# Access Compliance Report

## Public Rights-of-Way

### (Curb Ramps)

Intersection ID: 42795	Main Street: PLUMLEAF_DR	Cross Street: RED_VULCAN_CT	Location: SE
ADA ID: 1C90F3BF7ADF	Ramp Type: PerpDiag	Initial Pass/Fail: Fail	Overall Compliance: No
			Severity Score: 13.75

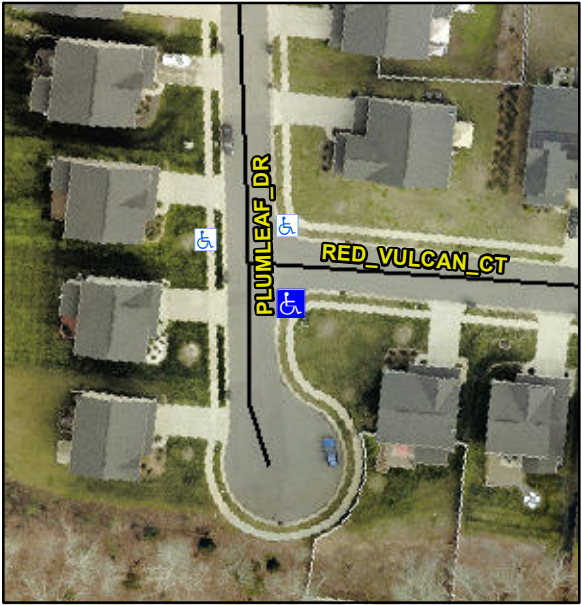
Codes/Mitigation Info/Possible Solution			Field Measurements/Component Compliance		
	Possible Solutions:		<b>Compliance</b>	<b>Description</b>	<b>Data</b>
	<b>Remove &amp; Replace Curb Ramp With Two New Directional Ramps or Equivalent.</b>		<b>No</b>	Ramp Length (in)	47.0
			<b>Yes</b>	Ramp Width (in)	48.0
			<b>N/A</b>	Flare Type LT	N/A
			<b>N/A</b>	Flare Slope LT (%)	N/A
			<b>N/A</b>	Flare Traversable LT?	N/A
			<b>N/A</b>	Landing Length (in)	N/A
			<b>N/A</b>	Landing Width (in)	N/A
			<b>N/A</b>	Landing Slope (%)	N/A
			<b>N/A</b>	Landing X Slope (%)	N/A
			<b>N/A</b>	Landing Curb? (Y/N)	N/A
			<b>N/A</b>	Shared Landing?	N/A
			<b>N/A</b>	Gutter Ponding?	N/A
			<b>N/A</b>	Gutter Lip Ht (in)	N/A
			<b>No</b>	Painted X Walk1?	N/A
				X Walk 1 Direction	To N
			<b>N/A</b>	X Walk 1 Width (in)	N/A
				X Walk 1 Slope (%)	0.3
				X Walk 1 X Slope (%)	4.7
			<b>N/A</b>	Ramp inside XWalk1?	N/A
<p>Surveyor Notes:</p> <p><b>N/A</b></p> <p>PROW/ADA:</p> <p><b>Not Found, R304.2.2, R304.5.3</b></p>			<b>N/A</b>	Flare Type RT	N/A

<b>N/A</b>	Flare Slope RT (%)	N/A
			<b>N/A</b>	Flare Traversable RT?	N/A
			<b>N/A</b>	DWS Provided?	N/A
			<b>N/A</b>	DWS Contrast?	N/A
			<b>N/A</b>	DWS Length (in)	N/A
			<b>N/A</b>	DWS Full Width?	N/A
			<b>N/A</b>	DWS Offset (in)	N/A
			<b>N/A</b>	Gutter Slope (%)	N/A
			<b>N/A</b>	Gutter X Slope (%)	N/A
			<b>No</b>	Painted X Walk2?	N/A
				X Walk 2 Direction	To W
			<b>N/A</b>	X Walk 2 Width (in)	N/A
				X Walk 2 Slope (%)	1.3
				X Walk 2 X Slope (%)	1.5
			<b>N/A</b>	Ramp inside XWalk2?	N/A
			<b>N/A</b>	Clear Space?	N/A
			<b>N/A</b>	Clear Space to XWalk (in)	N/A
			<b>N/A</b>	Storm Grate/Utility Hazard?	N/A
				Storm Grate/Utility Type	
<p>Total Cost:</p> <p><b>\$ 3200.00</b></p>			<b>N/A</b>		<b>N/A</b>
			<b>Yes</b>	Surface Condition? (G/P)	<b>Good</b>
